CP-200800123
Log # TXX-08012

SUBJECT: COMANCHE PEAK STEAM ELECTRIC STATION
DOCKET NOS. 50-445 AND 50-446
SUPPLEMENT TO LICENSE AMENDMENT REQUEST (LAR) 07-003
RESPONSE TO REQUEST FOR ADDITIONAL INFORMATION RELATED TO
LICENSE AMENDMENT REQUEST ASSOCIATED WITH METHODOLOGY
USED TO ESTABLISH CORE OPERATING LIMITS AND
LAR 07-004 REVISION TO THE OPERATING LICENSE AND TECHNICAL
SPECIFICATION 1.0, "USE AND APPLICATION" TO REVISE RATED THERMAL
POWER FROM 3458 MWT TO 3612 MWT
(TAC NOS. MD5243 AND MD5244) AND (TAC NOS. MD6615 AND MD6616)

Attachment 1 (LAR 07-003, Methodology)
Section 2.8, Anticipated Transients Without Scram

Figure 2.8-1 Critical Power Trajectory for Loss of Load ATWS at Uprated NSSS Power Conditions (3,628 MWt)

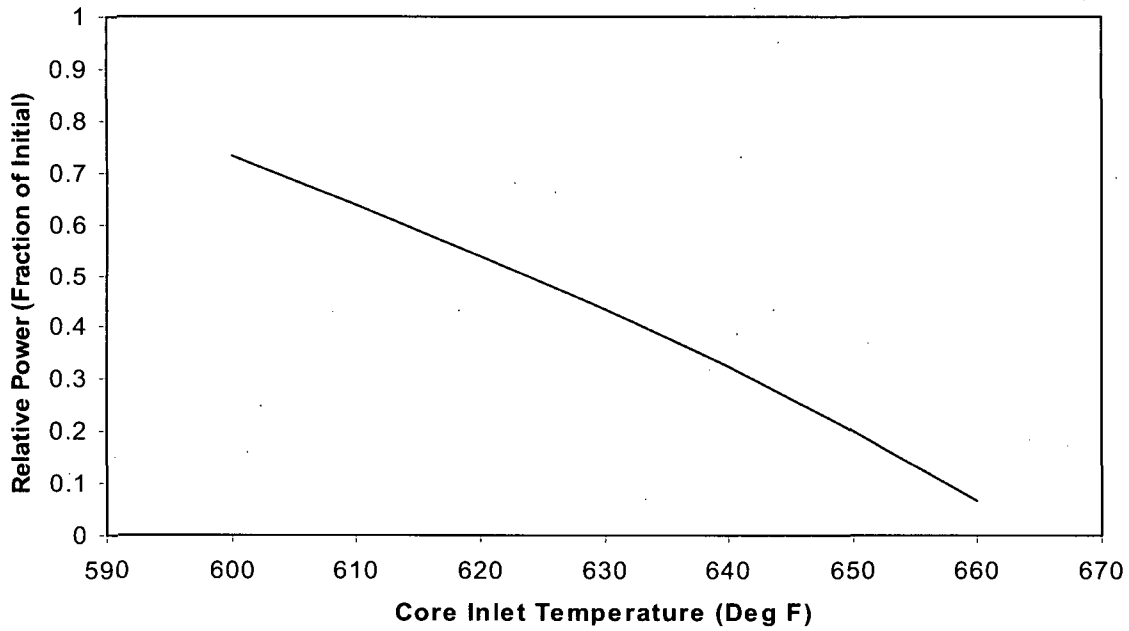
CPT curves were calculated for CPNPP Unit 1 with Westinghouse $\Delta 76$ steam generators at an uprated NSSS power level of 3,628 MWt. These critical power trajectory curves for the LOL and LONF ATWS transients are shown in Figures 2.8.5.7-1 and 2.8.5.7-2, respectively.
